Meeting Agenda

Franklin Municipal Planning Commission

Thursday, September 23,
2021

5. South Park Subdivision, Site Plan, Lot 17, Creating 33,500 Square Feet Of Institutional Space, On 4.57 Acres, Located At 143 Southeast Parkway. (CONSENT AGENDA)

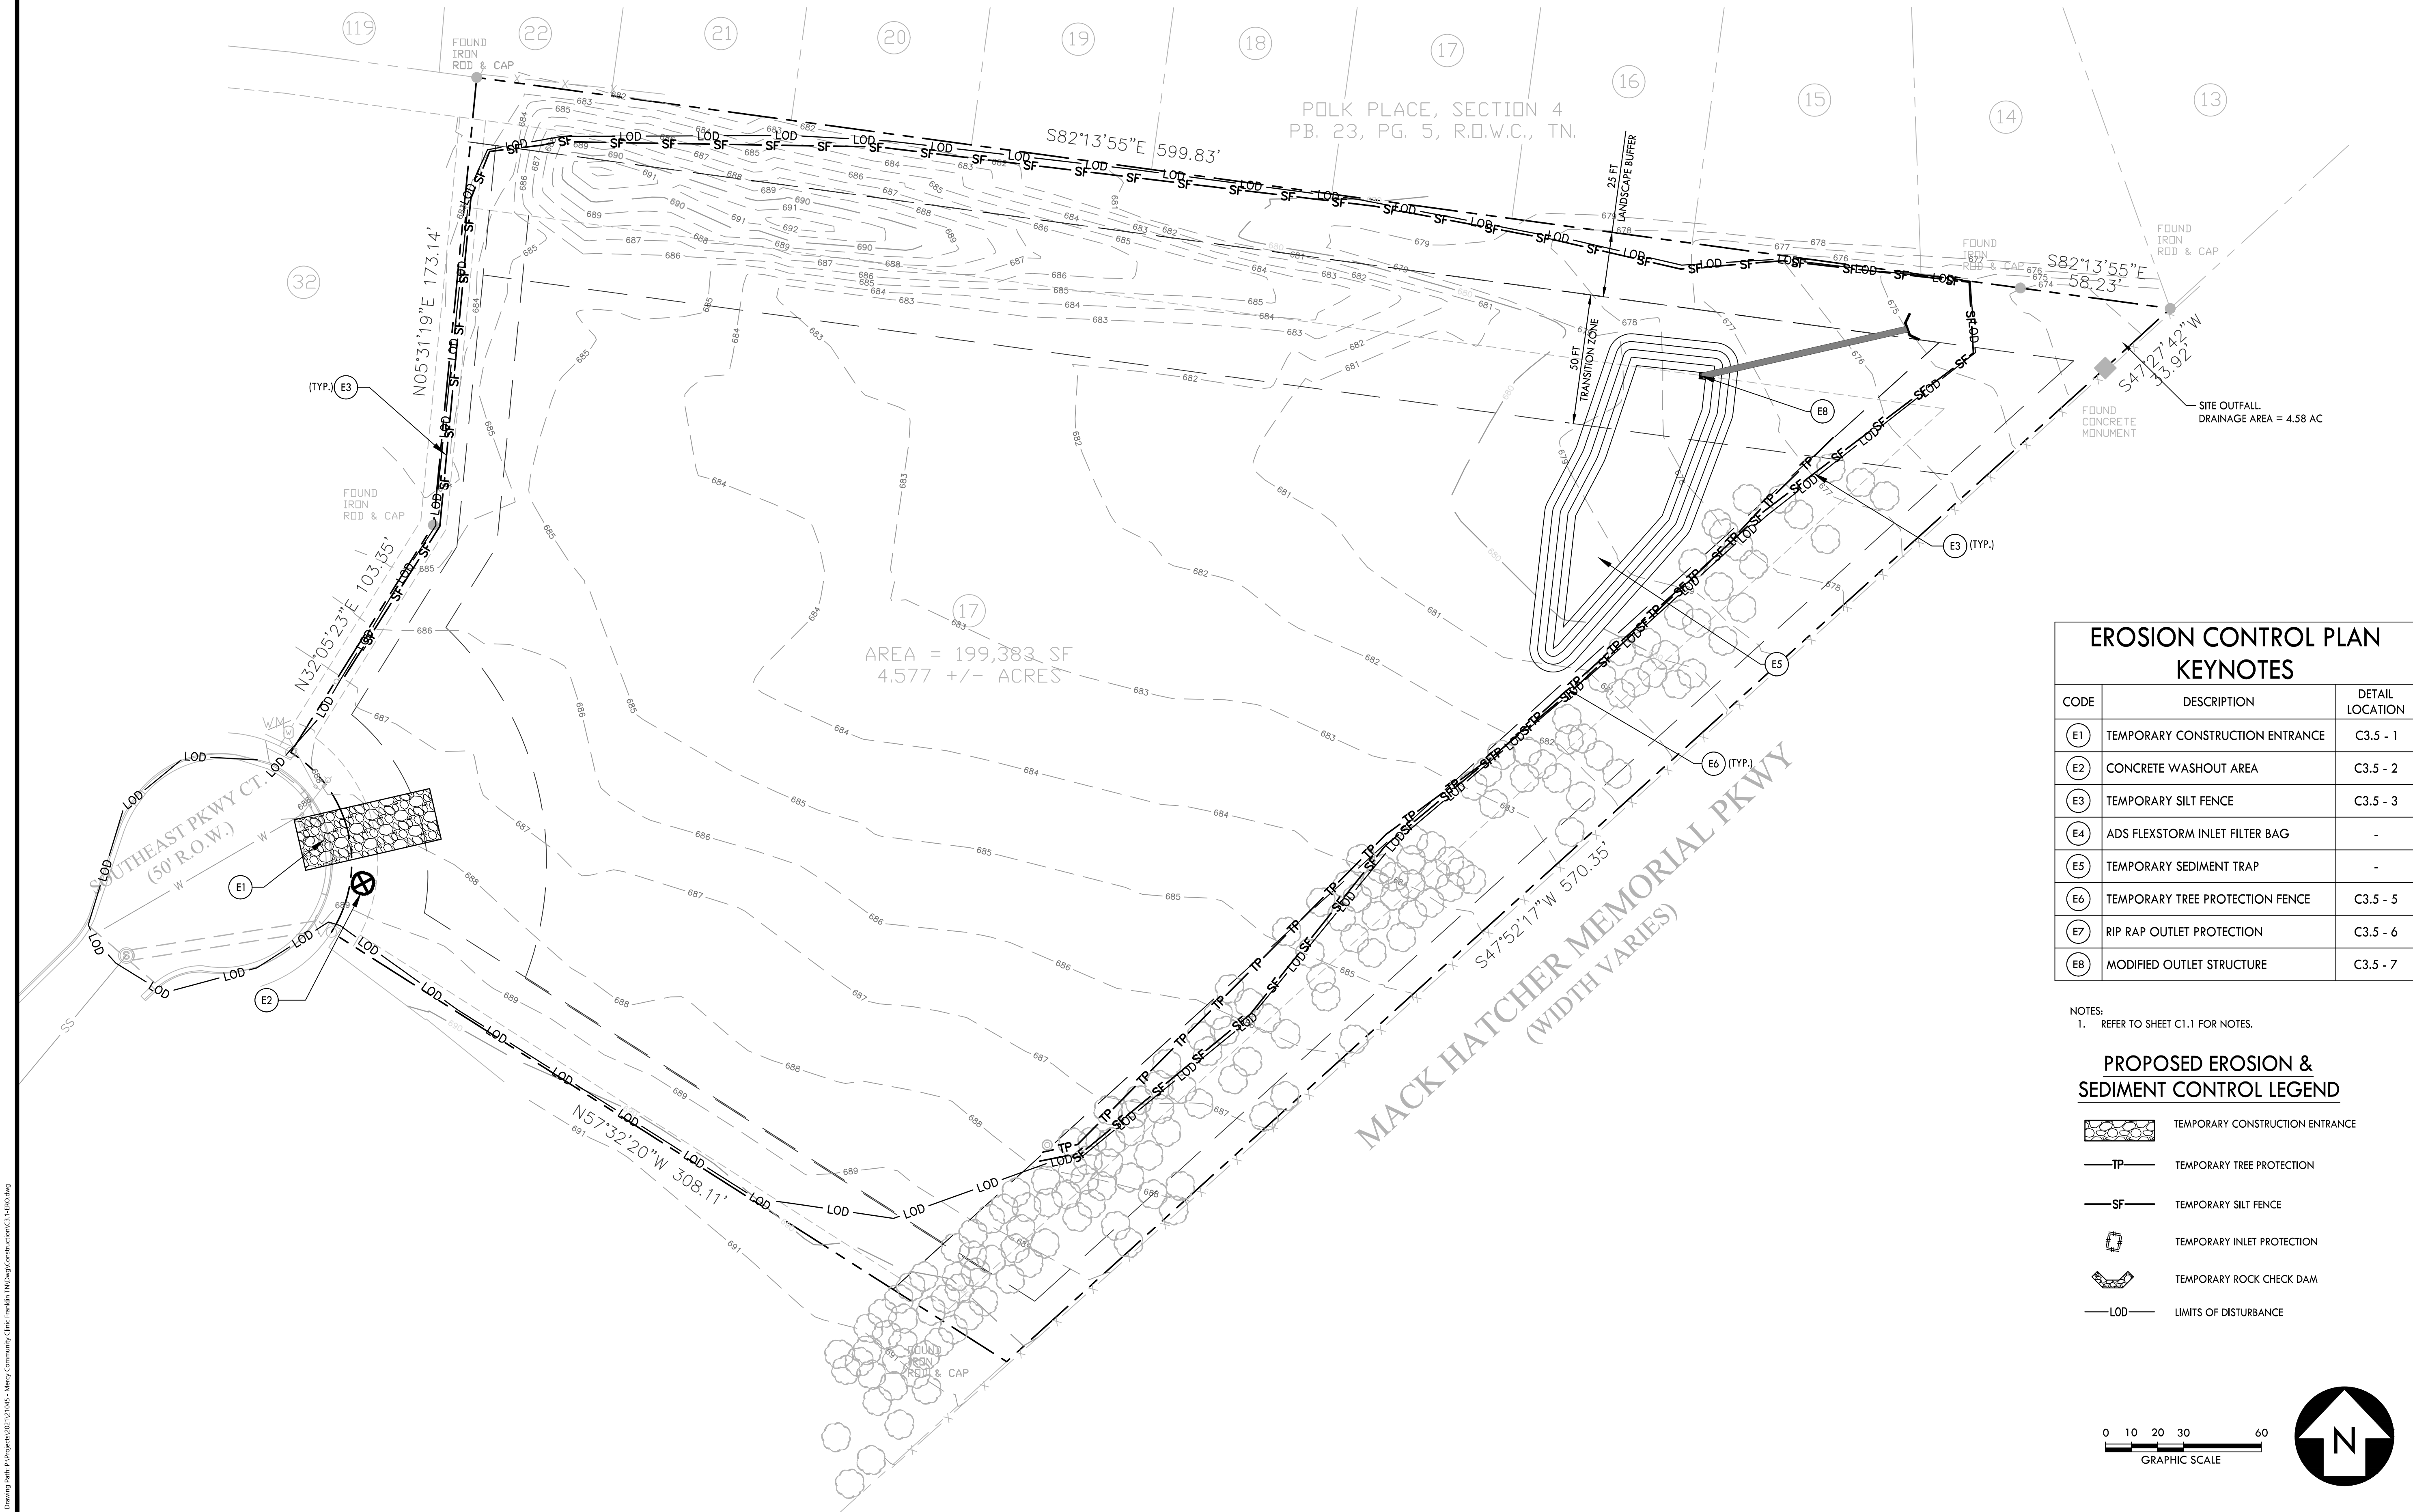
Is the 8" orifice at 679.00 to be closed off during construction? If so ensure it is clear on the detail for modified outlet structure.

Is the stone/rip-rap to be placed in front of/around the modified outlet structure?

C5.1
SANITARY SEWER
PLAN & PROFILE

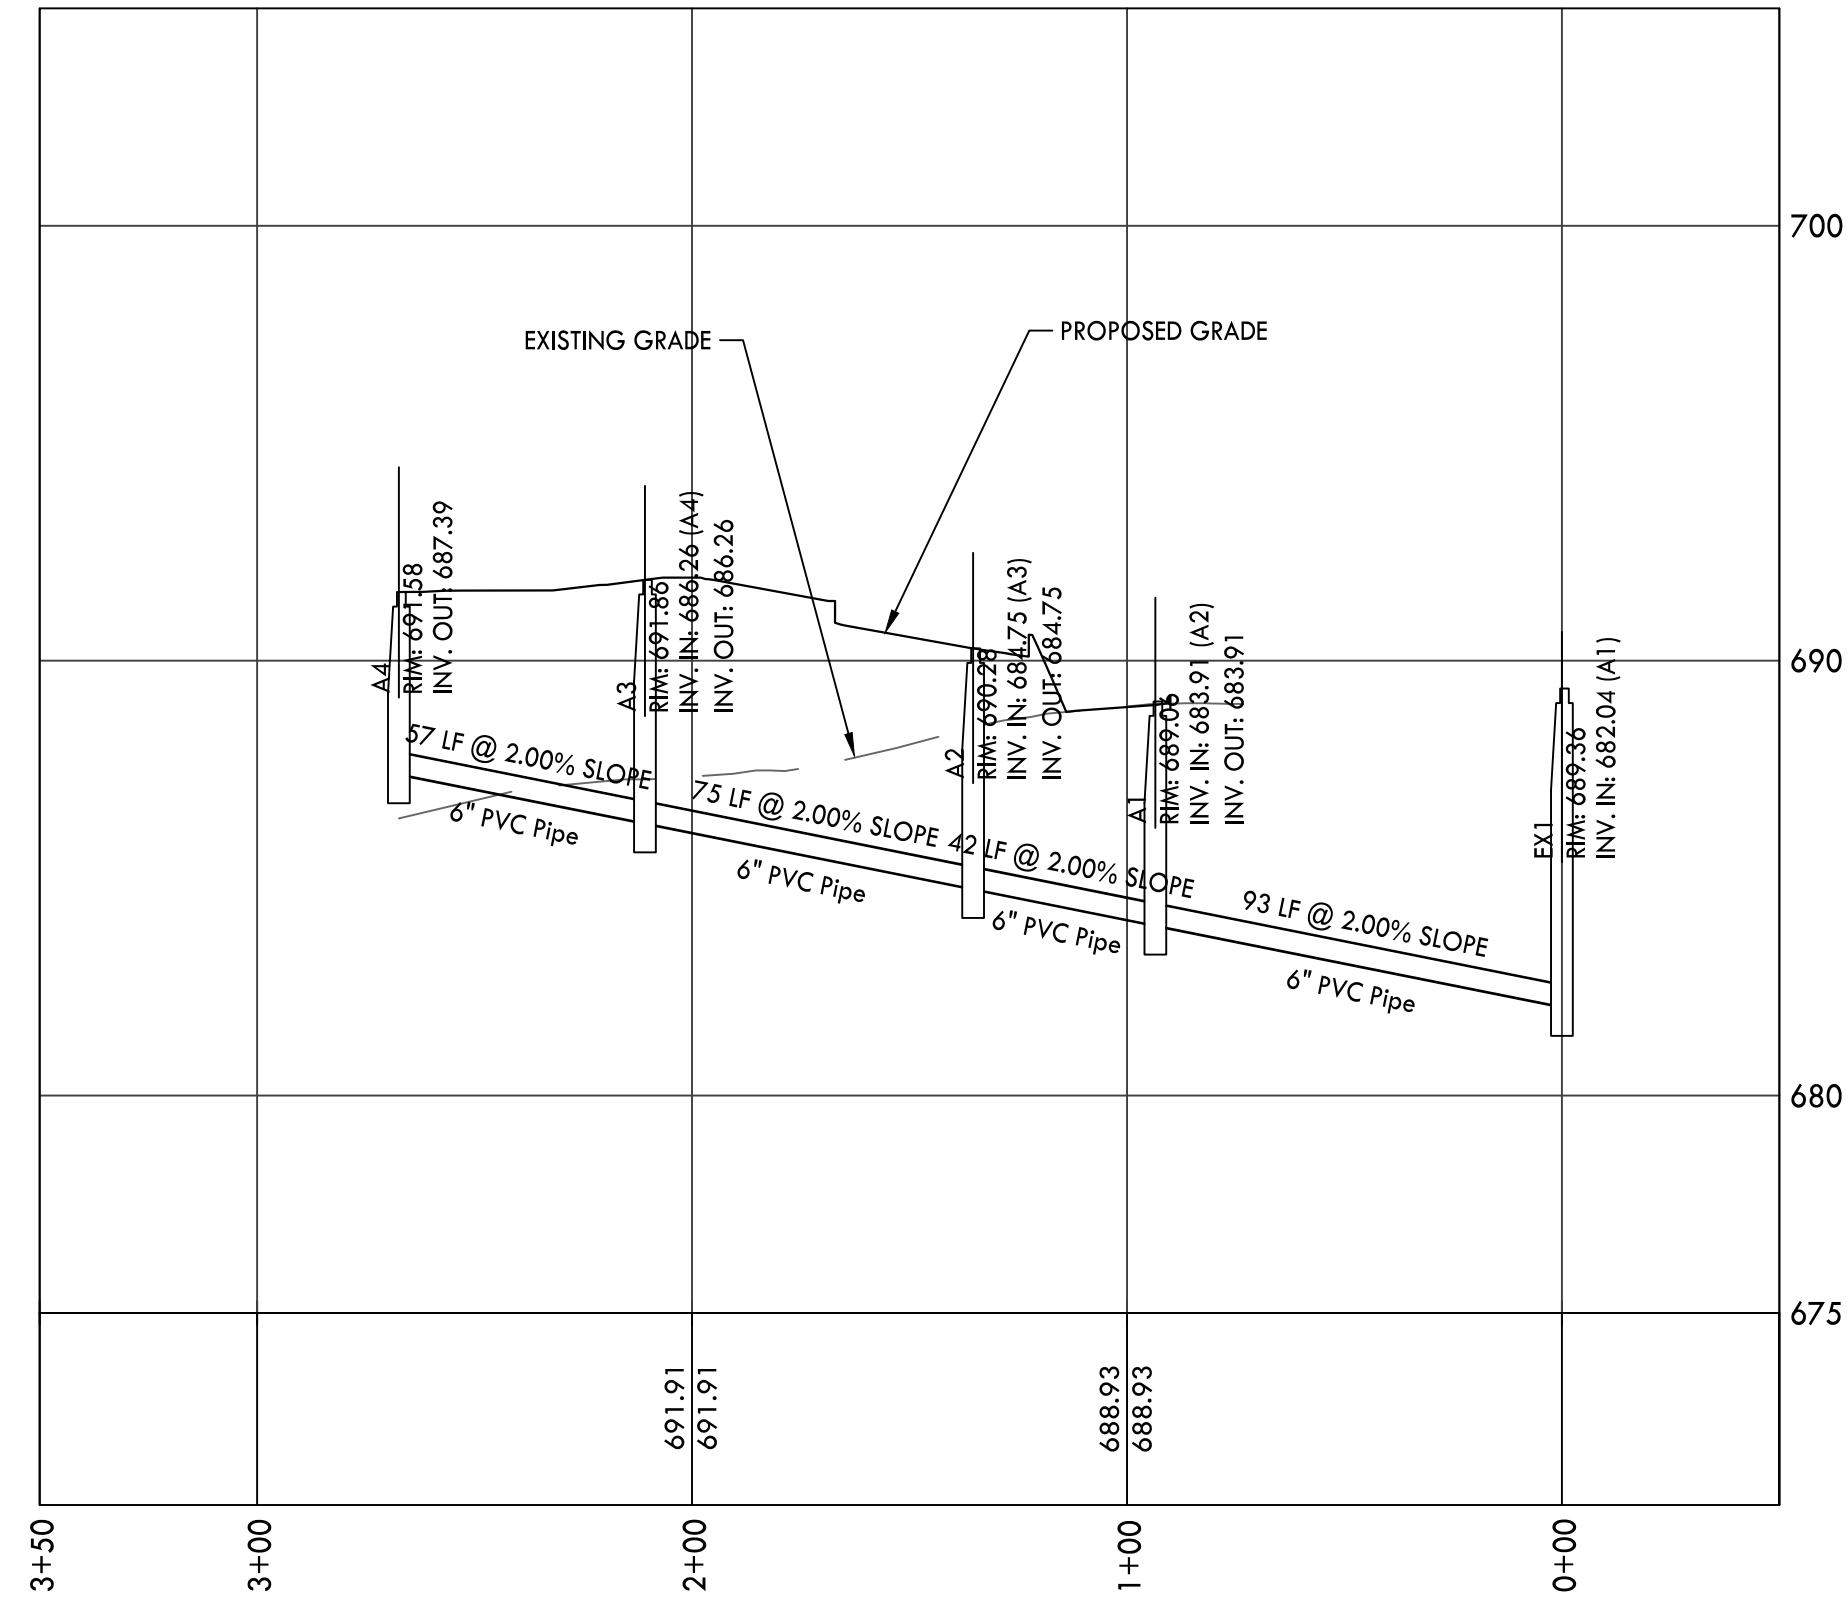
Applicant shall show the invert out elevation for MH EX1 in profile on C5.1, similar to that shown in the previous submittal.
